EG&G ROCKY FLATS

OPERABLE UNIT SEVEN (OU 7) TRANSFER OF DECEMBER 8, 1994 AGENCY MEETING MINUTES

**OPERABLE UNIT 7 AGENCY INTERFACE MEETING
STRATEGY FOR LANDFILL CLOSURE
December 8, 1994**

Proposed
Area of Contamination

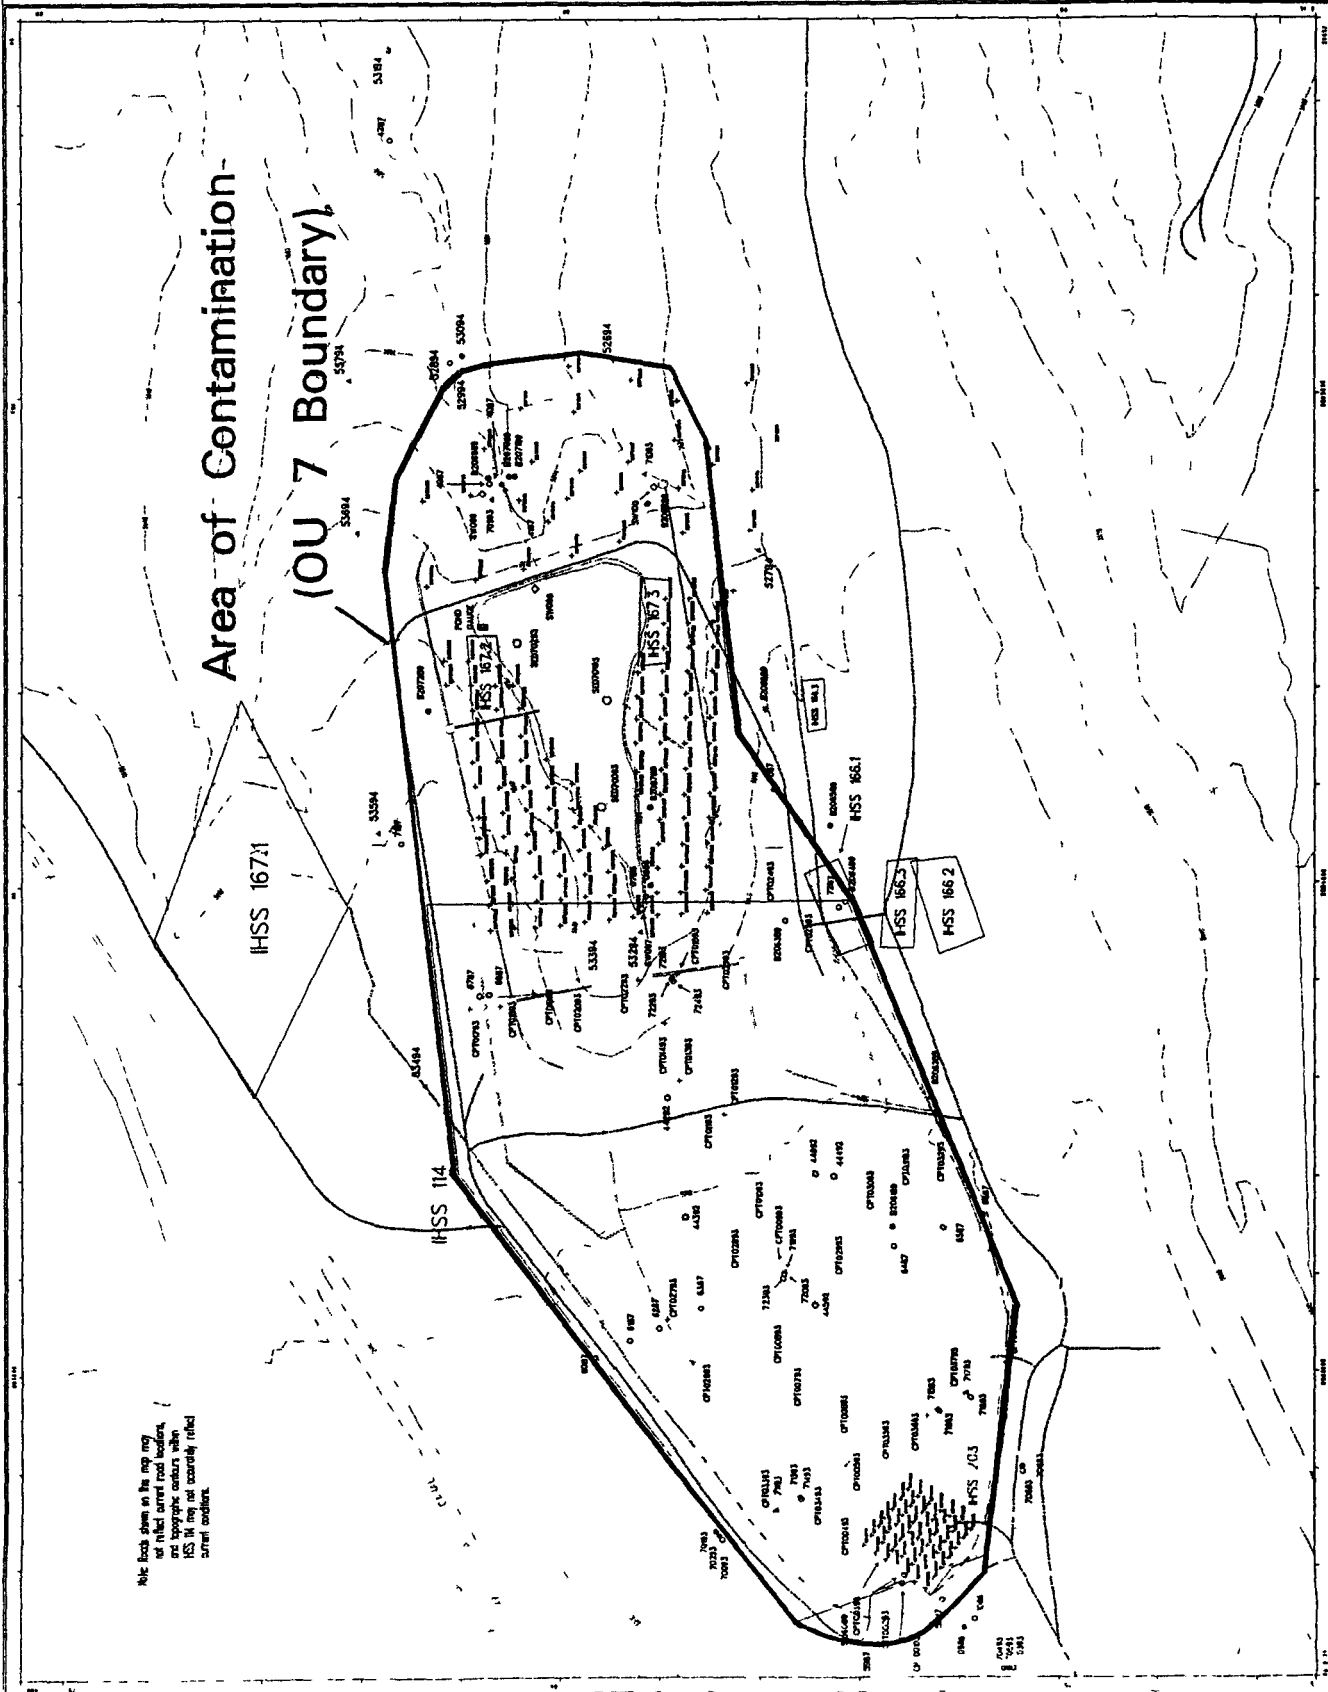
DOE proposes to establish the area of contamination (AOC) at OU 7 as shown in the attached figure. This area includes the Present Landfill, asbestos disposal areas, pond sediments, and soils in spray evaporation areas.

Establish Area of Concern EG&G/DOE ~~with~~ will provide a proposal with regulatory citations. The proposal will be sent to EPA/CDPHE for review. The regulatory analysis will provide a strict analysis of both RCRA and CERCLA.

Outcome: Further discussion on this issue is required. DOE/EG&G will provide a regulatory analysis under RCRA and CERCLA to justify consolidation of materials released from the landfill.

Establish Area of Concern - EG&G/DOE will provide a proposal with CERCLA and RCRA regulatory analyses to justify consolidation of the materials released from the landfill.
